COMMISSION ON COMMUNITY INVESTMENT AND INFRASTRUCTURE

RESOLUTION NO. 34-2020

CONDITIONALLY APPROVING AMENDMENTS TO THE REVISED MAJOR PHASE FOR BLOCKS 41-43 APPLICATION AND THE BASIC CONCEPT / SCHEMATIC DESIGN FOR MISSION BAY SOUTH BLOCK 43, PARCEL 7 (1450 OWENS STREET) TO DEVELOP A MIXED-USE LIFE SCIENCES FACILITY; AND, ADOPTING ENVIRONMENTAL REVIEW FINDINGS PURSUANT TO THE CALIFORNIA ENVIRONMENTAL QUALITY ACT; MISSION BAY SOUTH REDEVELOPMENT PROJECT AREA

Landscape Site Plan

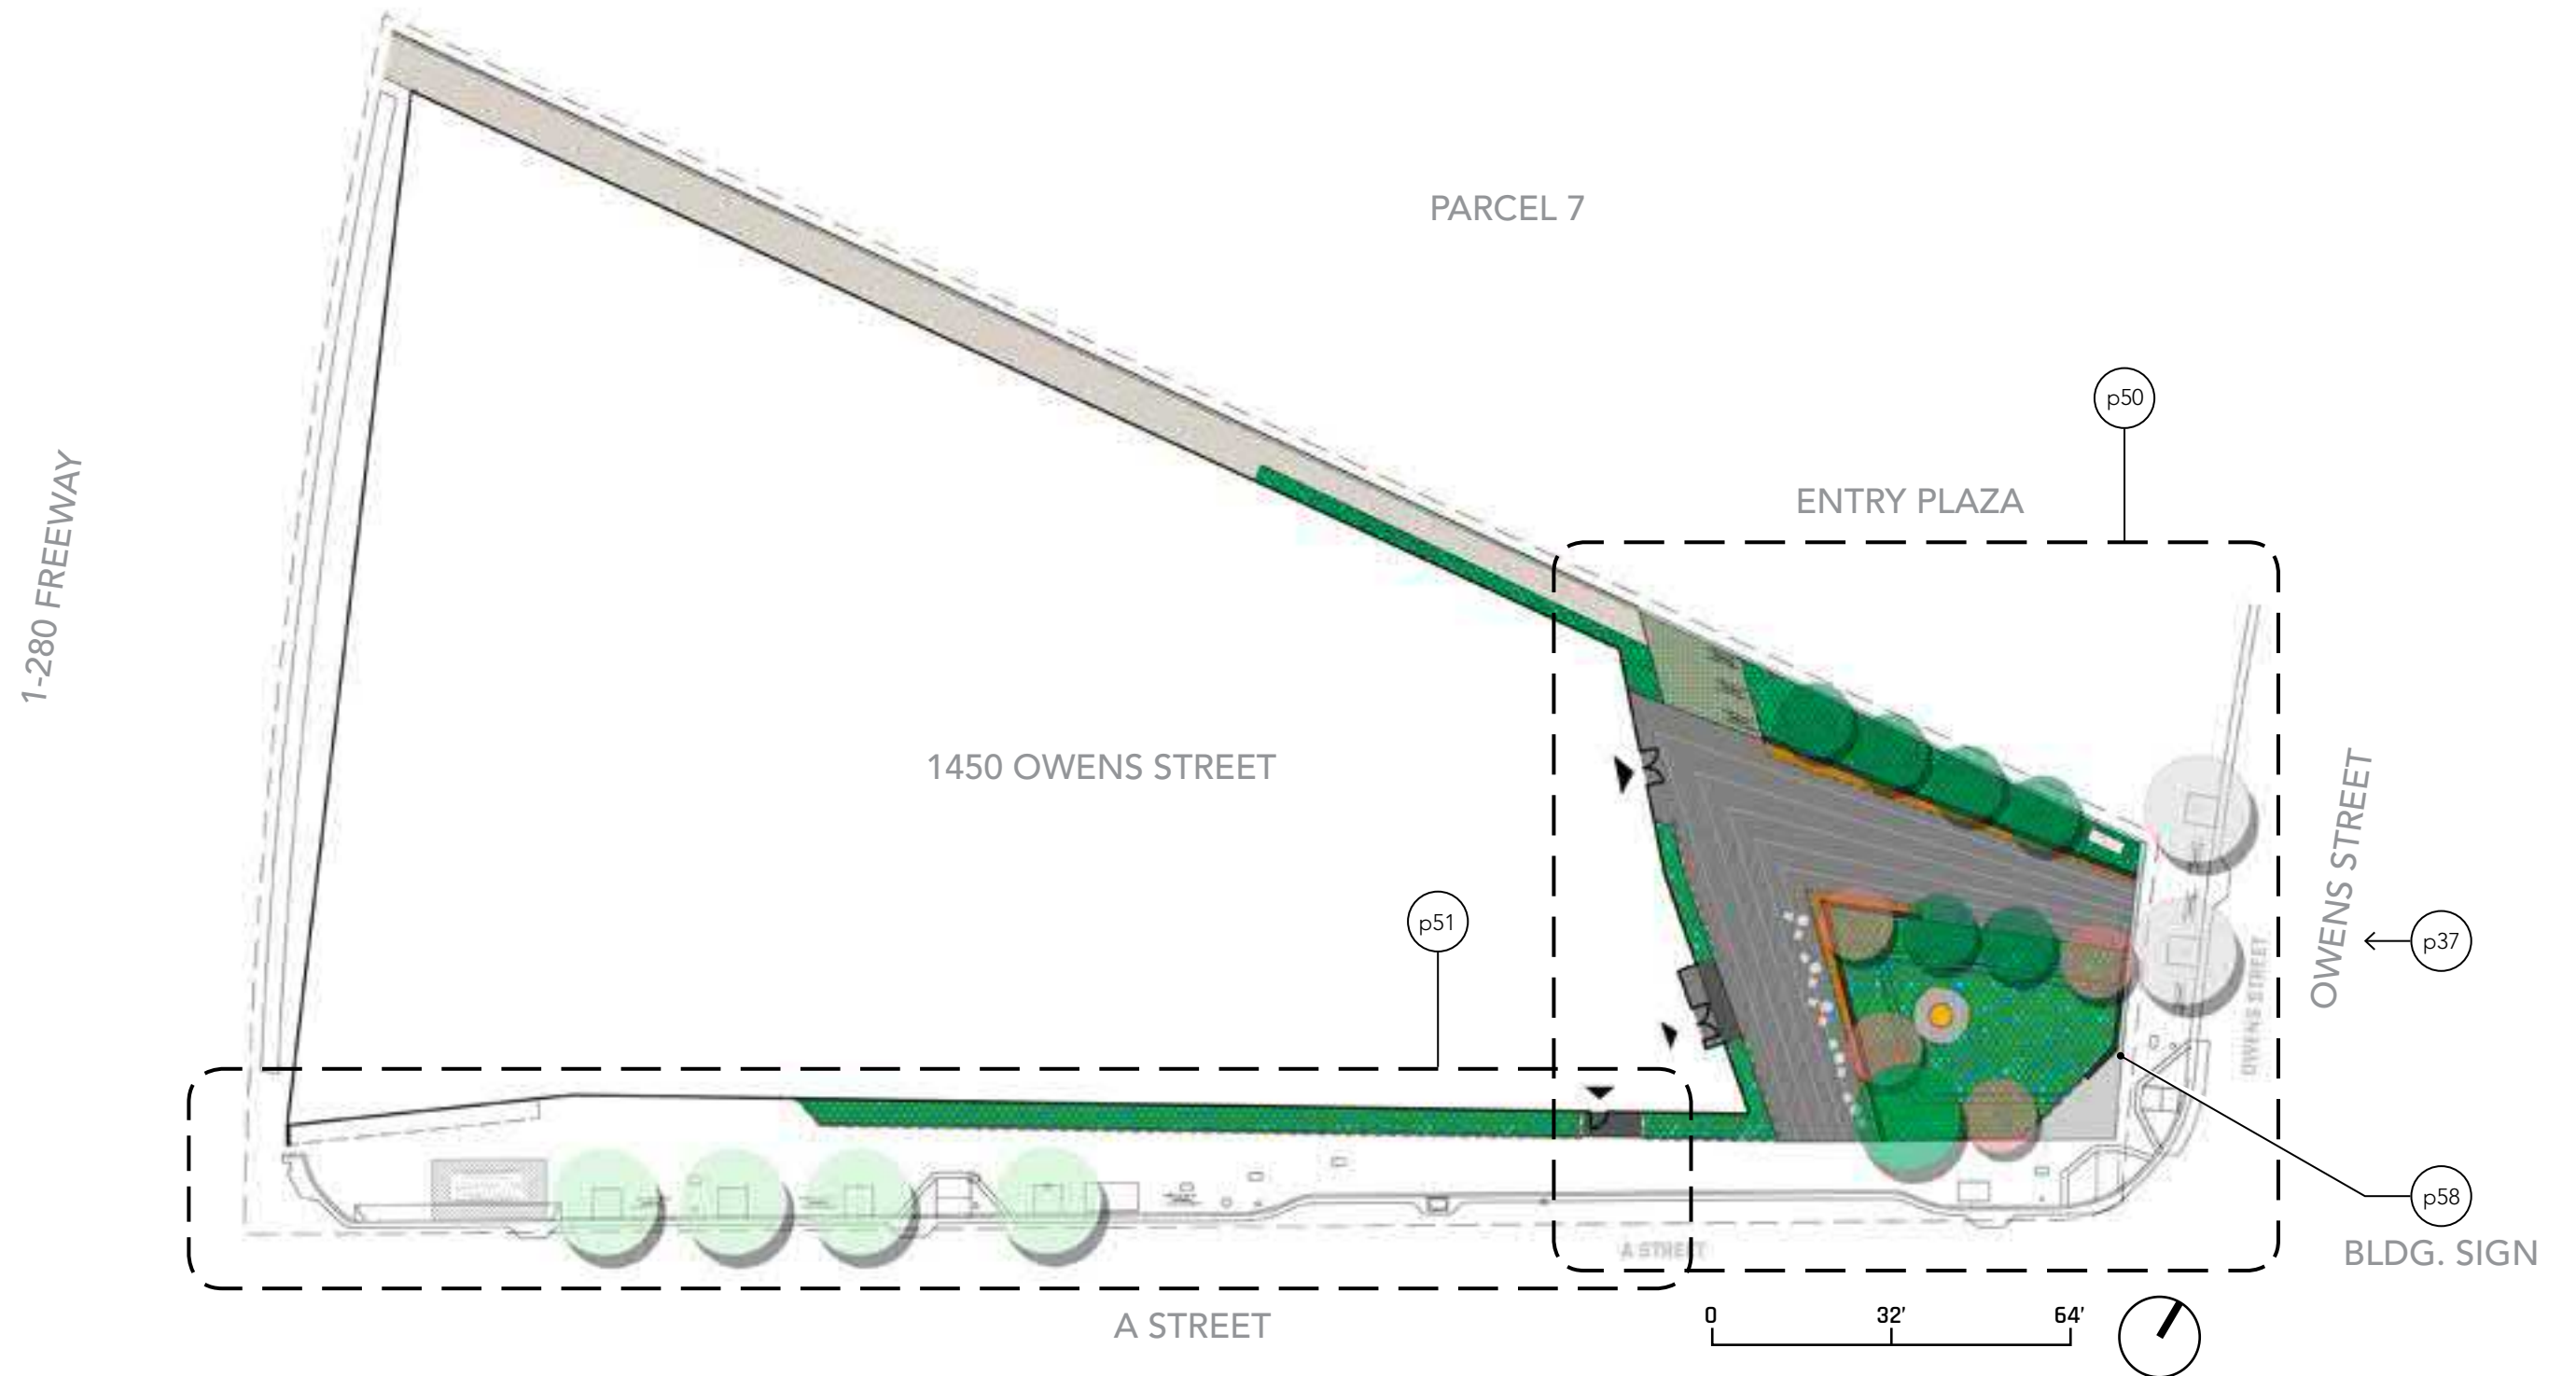
6. Landscape Plans. Provide detailed landscape plans, including plans for entry plaza, all setback zones, courtyards, mechanical and utility screening and balconies.
